MOTOR COACH
INDUSTRIES

SUBJECT: SAFETY RECALL OF MCI COACHES WITH ELECTRONIC STABILITY CONTROL

Ref.: **NHTSA # (MCI) 11V-524**
NHTSA # (Meritor WABCO) 11E-039
TRANSPORT CANADA #TC 2011-377
MCI Service Bulletin 371

Service Bulletin No. 371

Figure 1.

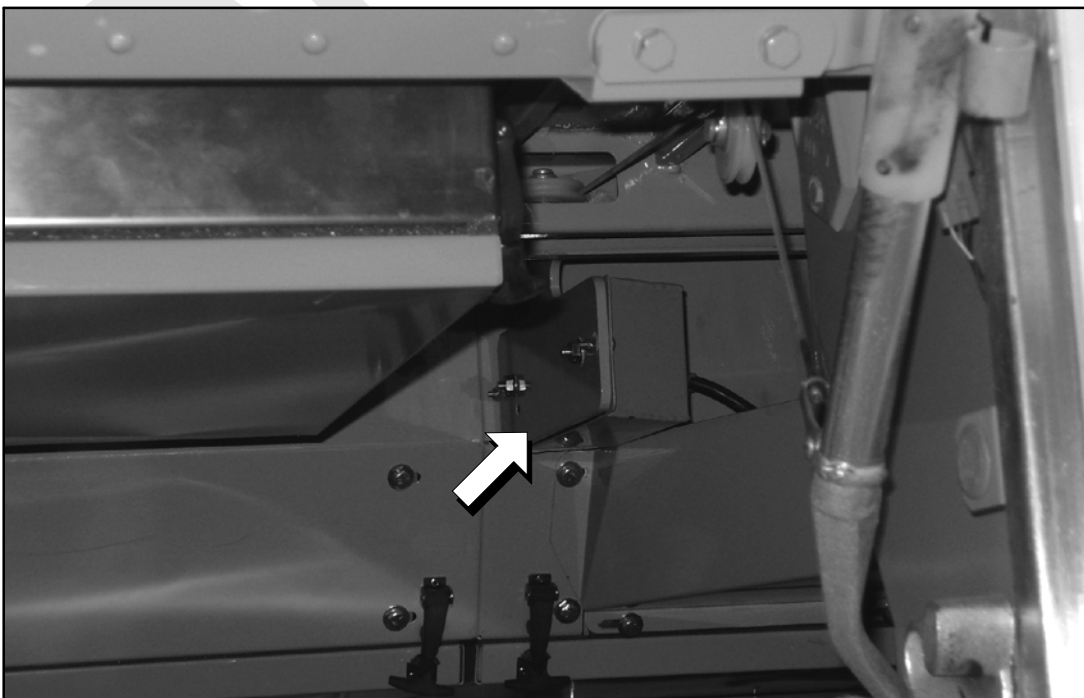
3. Open the #3 baggage bay compartment curbside and roadside doors. Insert the positive lock pin to secure the door in the open position.
4. Locate the ESC module on the rear section of the roadside baggage bay compartment (refer to Figure 1).
5. Remove and retain the cover mounting hardware (refer to Figure 1). Place the cover and hardware aside to be re-installed at a later step in this procedure.

7. Remove and retain the ESC module mounting hardware. Remove and retain the existing ESC module to be returned to MCI.
8. Using the mounting hardware removed in Step 7, install the new ESC module, p/n 04-31-1110.
9. Re-connect the harness disconnected in Step 6.
10. Using the mounting hardware removed in Step 4, re-install the ESC module cover.
11. Close the baggage bay compartment doors.
12. Proceed with Step 1 to Step 6 on Pages 2 to 4 of the attached Meritor–WABCO Technical Bulletin TP– 1205 / Procedures for ECUs with Software Revision E435, E436, E440 or E441, following all warnings and cautions therein.

Figure 3. Reference photo.

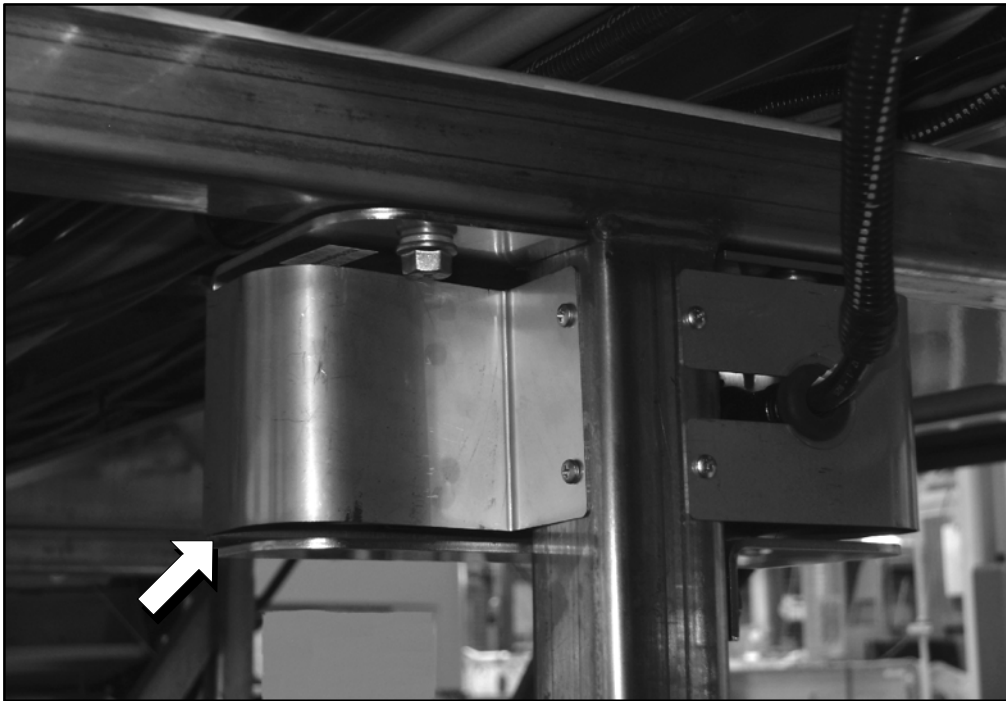
13. Open the #3 baggage bay compartment curbside and roadside doors.
14. Locate the ESC module on the center post of the baggage bay compartment (refer to Figure 3).

17. Remove and retain the ESC module mounting hardware. Remove and retain the existing ESC module to be returned to MCI.
18. Using the mounting hardware removed in Step 17. , install the new ESC module, p/n 04-31-1110.
19. Re-connect the harness disconnected in Step 16.
20. Using the mounting hardware removed in Step 15. , re-install the ESC module cover.
21. Close the baggage bay compartment doors.
22. Proceed with Step 1 to Step 6 on Pages 2 to 4 of the attached Meritor-WABCO Technical Bulletin TP-1205 / Procedures for ECUs with Software Revision E435, E436, E440 or E441, following all warnings and cautions therein.
